SINAMICSG120 / G120C / G120D, G110M / ET 200pro FC-2

Product information, FW 4.7 SP10

04/2018

New fault values in fault F01682

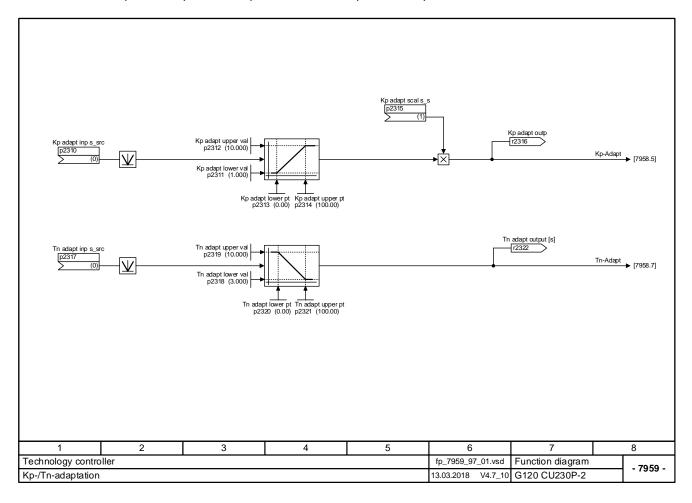
56: For "GX" Power Modules, encoderless monitoring functions are not supported. 9586: Set value of p9586/p9386 is greater than the supported maximum value.

9588: Set value of p9588/p9388 is greater than the supported maximum value.

9589: Set value of p9589/p9389 is greater than the supported maximum value.
